## Information for T1 and T1 EVO2 Owners

Thank you for purchasing the #301117 Composite Chassis. This chassis is made from an extraordinary new composite material for light weight, excellent rigidity and toughness, and unique memory effect that returns the chassis to its original shape even after sustaining deforming impacts.

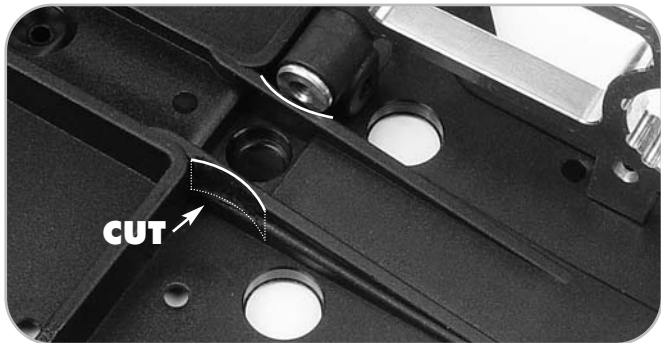
You must perform a small modification to the chassis to properly mount the lower suspension pin holders with aluminum nuts to the front bulk-heads.

On the area indicated in the image, please use a file or a moto-tool to carefully remove a small amount of material from both sides of the inner channel of the chassis as shown. This will allow the alu. nut to be used without touching the chassis. Be careful not to remove too much material so you do not make a hole in the chassis.
